**Subject:** Houghton/Everest Neighborhood Center  
File No. CAM16-02742

**Subject:** Houghton/Everest Neighborhood Center  
 File No. CAM16-02742

**Subject:** **HOUGHTON COMMUNITY COUNCIL RECOMMENDATION ON PROPOSED COMPREHENSIVE PLAN AND MUNICIPAL CODE AMENDMENTS FOR HOUGHTON/EVEREST NEIGHBORHOOD CENTER (FILE CAM16-02742)**

# Plate 34 O Approximate Pedestrian Circulation and Vehicular Access in HENC

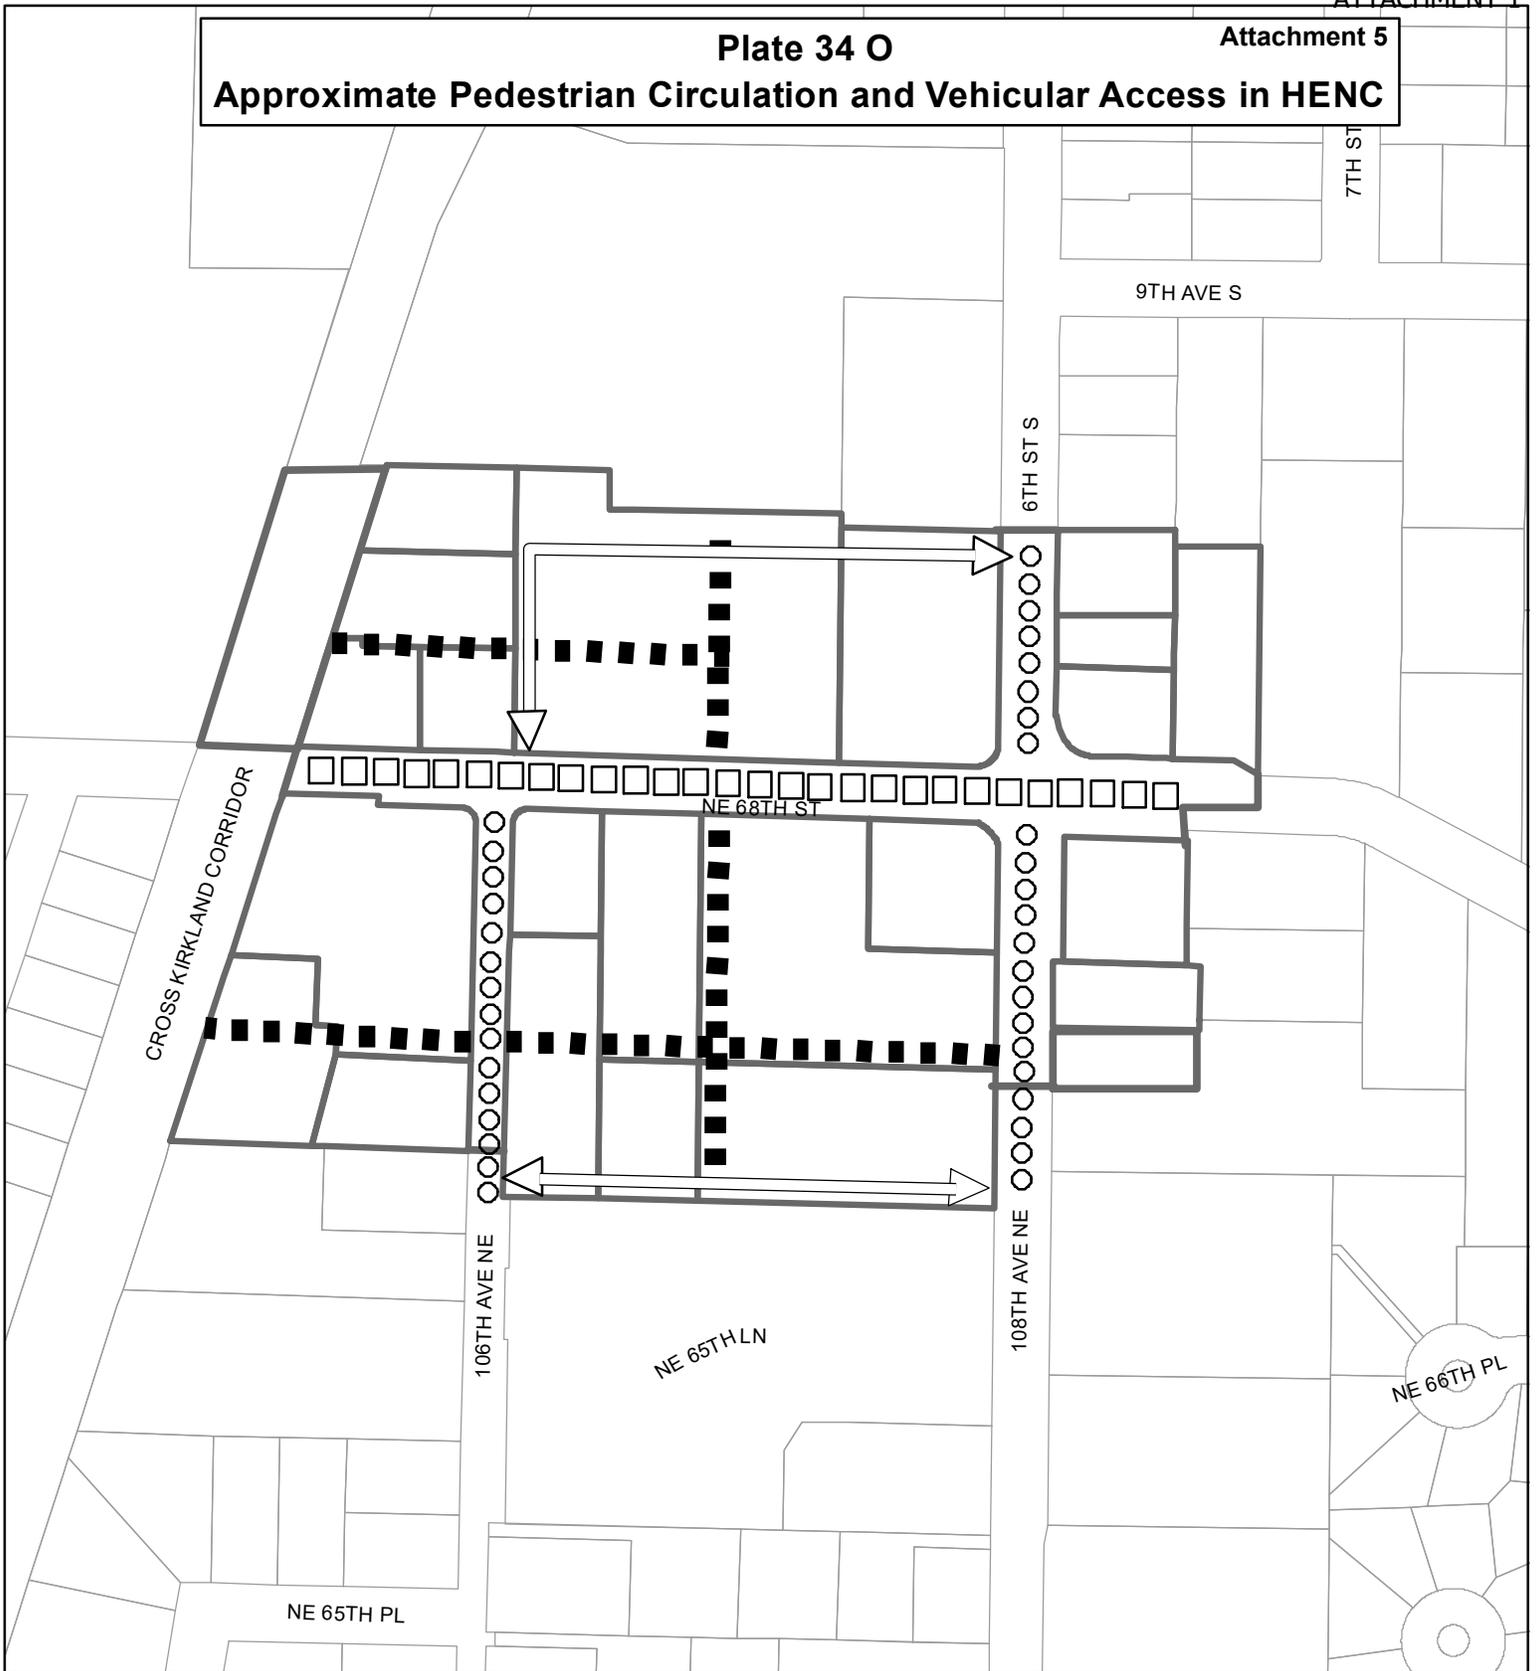
Page 269 – Plate 34 O: Approximate Pedestrian Circulation and Vehicular Access in HENC was replaced by Attachment 5 – changes made to this Plate are to clarify that vehicular access locations are approximate.
